**Report on Heavy Goods Vehicle Swept Path analysis
within Messing village**

Compiled and researched by the Messing and Inworth Action Group

A12 Chelmsford to A120 widening scheme

Inworth Road Roundabout design checks:

1.0 From Kelvedon Road into Harborough Hall Road assuming no vehicles parked.

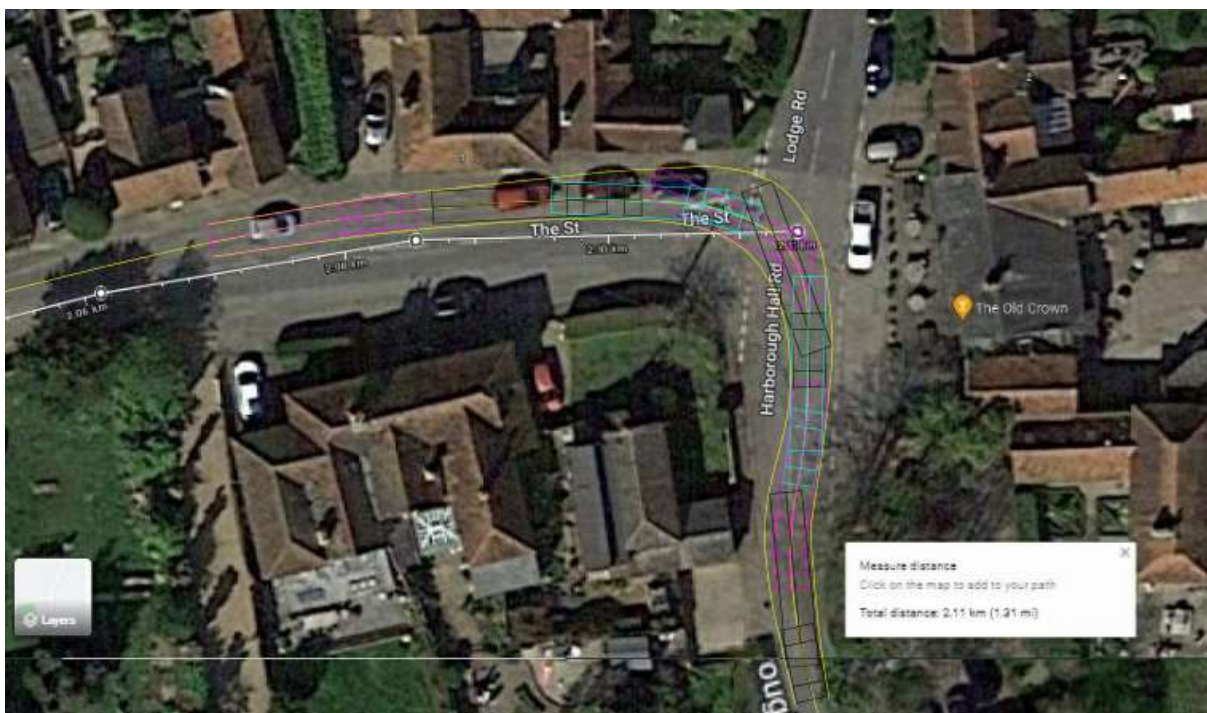
The design vehicle would be able to approach the T junction without impeding vehicles travelling in the opposite direction, on Kelvedon Road. After turning right into Harborough Hall Road, the design vehicle would occupy nearly the full width of the road and therefore require vehicles travelling in the opposite direction to give way. Harborough Hall Road is quite narrow making it difficult for vehicles travelling in the opposite direction to find somewhere to give way.

3.0 Harborough Hall Road to Kelvedon Road assuming no vehicles parked.

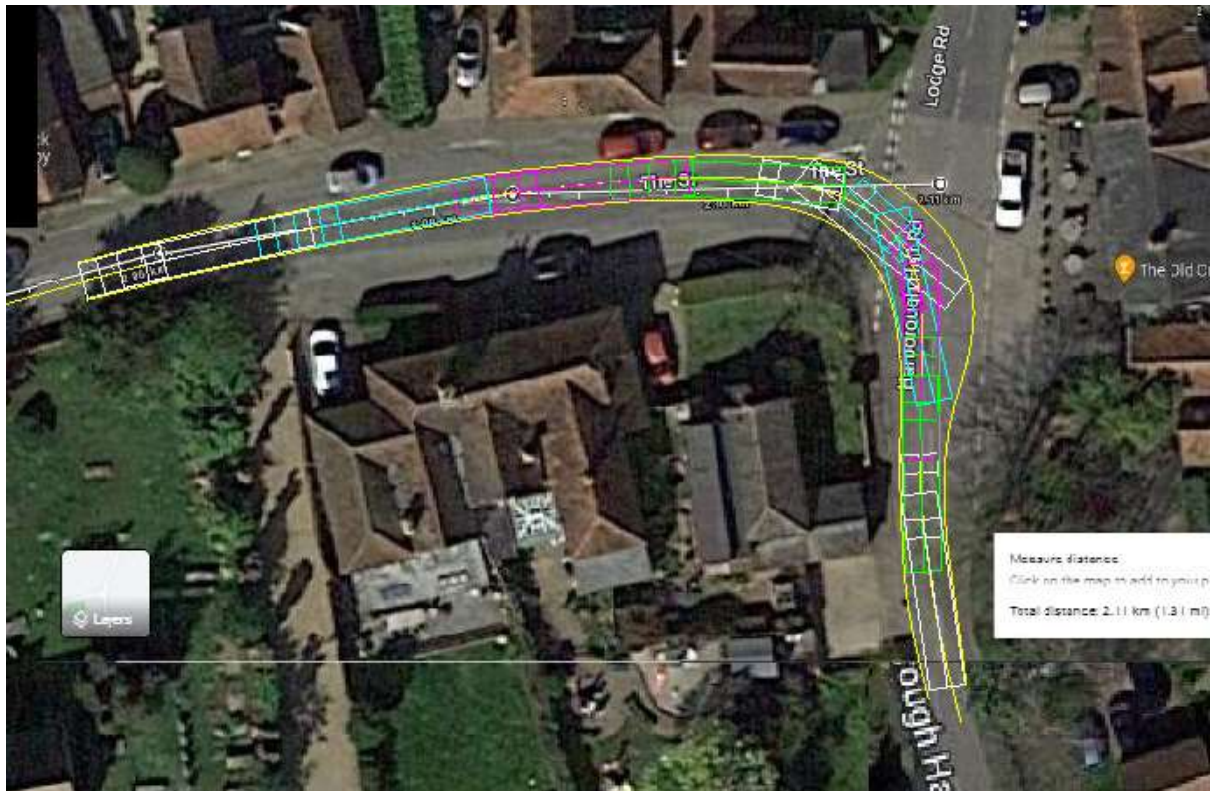
On approach to the T junction along Harborough Hall Road the design vehicle would occupy nearly the full width of that road. Where the road widens at the junction the design vehicle would need to occupy most of the opposing carriageway before turning left into Kelvedon Road, to allow for the swept path of the trailer. Vehicles travelling in the opposite direction would need to give way but with no parked vehicles there would be space to do this. On entering Kelvedon Road the design vehicle might need to cross into the opposite carriageway slightly. This would not leave much width for vehicles travelling in the opposite direction and most likely they would need to give way to the design vehicle.

4.0 Harbrough Hall Road to Kelvedon Road assuming with vehicles parked.

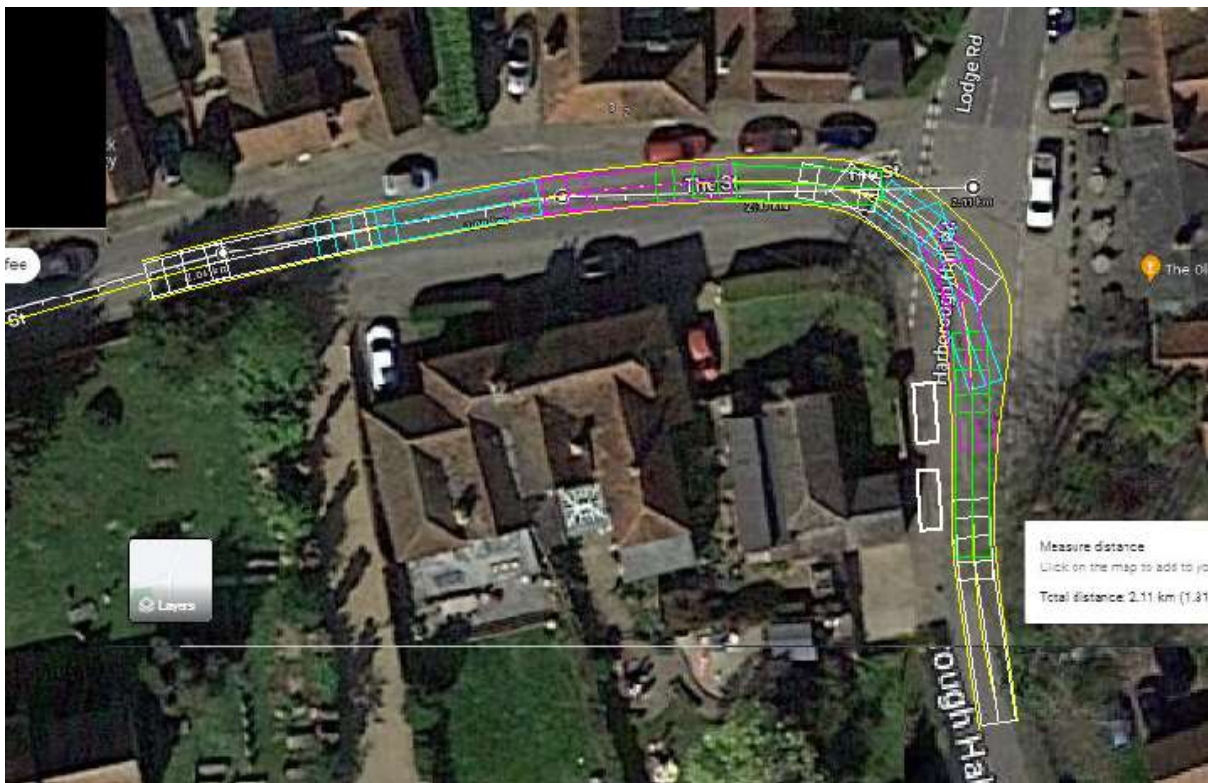
On approach to the T junction along Harbrough Hall Road the design vehicle would occupy nearly the full width of that road. Assuming there were vehicles parked on the west side of Harbrough Hall Road the design vehicle would need to move over to the opposing carriageway earlier than if no vehicles were parked. This would allow a better approach into Kelvedon Road by bringing the trailer further away from the nearside road edge before making the turn. Vehicles travelling in the opposite direction on Harbrough Hall Road would again need to give way while the design vehicle was completing its manoeuvre but there should be enough space available. The design vehicle would be able to avoid vehicles parked on the north side of Kelvedon Road. Vehicles travelling on Kelvedon Road towards the T junction would need to give way to the design vehicle.

1. Inworth Road Roundabout arm to B1023 in the direction of Feering and Kelvedon

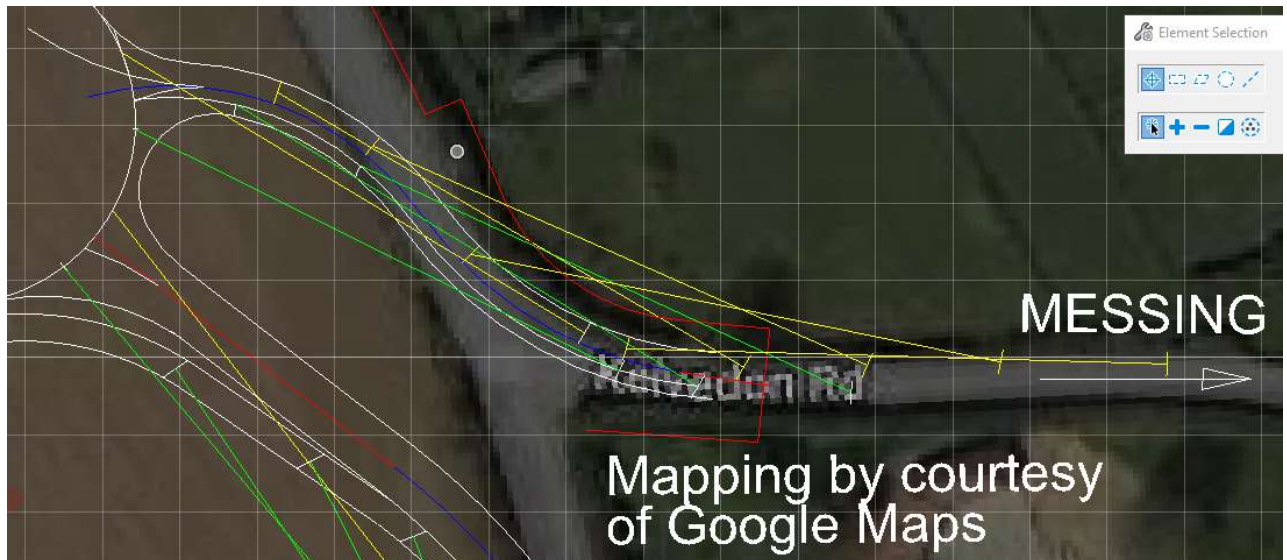
Design speed has been assumed to be 70 kph based on the vertical crest curve K value of 30 used. The B1023 Inworth Road in this area is currently subject to a 50 mph speed limit which equates to an 85 kph design speed. Does the designer intend to lower the speed limit to 40 mph to suit a 70 kph design speed?

- The value of 65m for a horizontal radius does not comply with DMRB standard CD 109 Highway Link Design, para. 2.11 which states:

- No transition curves have been provided between horizontal elements. This does not comply with CD 109, para. 4.12 which states:

- Forward visibility on approach to the roundabout will not comply with CD 109 unless the sight line passes outside the Red Line boundary into the property “Park Farm” (or “Stonefield Farm”?). Visibility would be further impeded by proposed tree planting.

- No verge widening has been provided in the design to allow for uninterrupted visibility for vehicles entering or leaving the roundabout.

- As with the approach to the roundabout, forward visibility on exiting the roundabout would not comply with DMRB CD 116 Geometric Design of Roundabouts unless the sight line passes outside the Red Line boundary into the property “Park Farm”.

The alignment is not long enough to make a judgement about visibility in the vertical plane. It would need to be extended further along the B1023 in order to see what the existing carriageway geometry is. The use of a vertical crest curve with $K = 30$ would indicate a 70 kph design speed since no relaxations are permitted on the immediate approach to a junction (CD 109 table 2.10, CD 109, para. 2.11). The sight line would most likely be impeded by property boundaries where it passes outside the Red Line boundary.

2. Inworth Road Roundabout arm to Kelvedon Rd. in the direction of Messing

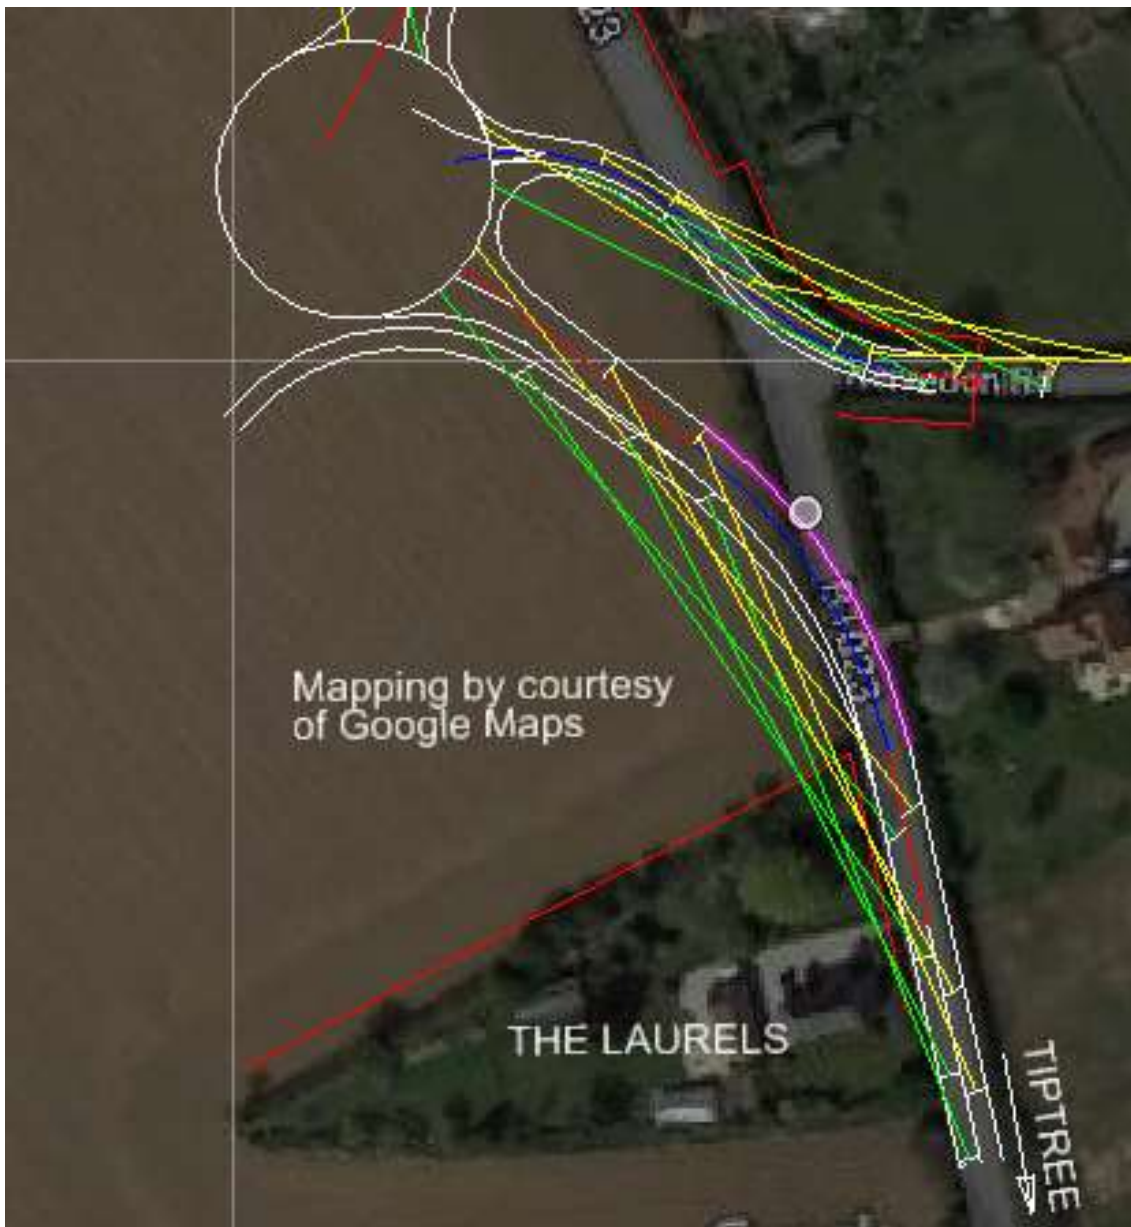
Design speed has been assumed to be 50 kph based on the vertical crest curve K value of 10 used. Kelvedon Road is currently subject to a national speed limit, which varies from 40mph to 60mph dependant on vehicle type. It would be interesting to know why a 50kph design speed has been chosen.

- The value of 50m and 40m for horizontal radii do not comply with DMRB standard CD 109, para. 2.11 which states:

- Sharp curves are not good practice on the approach to a roundabout.

- No transition curves have been provided between horizontal elements. This does not comply with CD 109, para. 4.12 which states:

- Forward visibility on approach to the roundabout will not comply with CD 109 unless the sight line passes outside the Red Line boundary on the north side of Kelvedon Road. Visibility may be further impeded by proposed tree planting.

The alignment is not long enough to make a judgement about visibility in the vertical plane. It would need to be extended further along Kelvedon Road in order to see what the existing carriageway geometry is. The use of a vertical crest curve with $K = 10$ would indicate a 50 kph design speed. Since no relaxations in vertical curvature are permitted on the immediate approach to a junction 50kph would be the highest value of design speed for a crest K value of 10 (CD 109 table 2.10, CD 109, para. 2.11). The sight line would most likely be impeded by property boundaries where it passes outside the Red Line boundary.
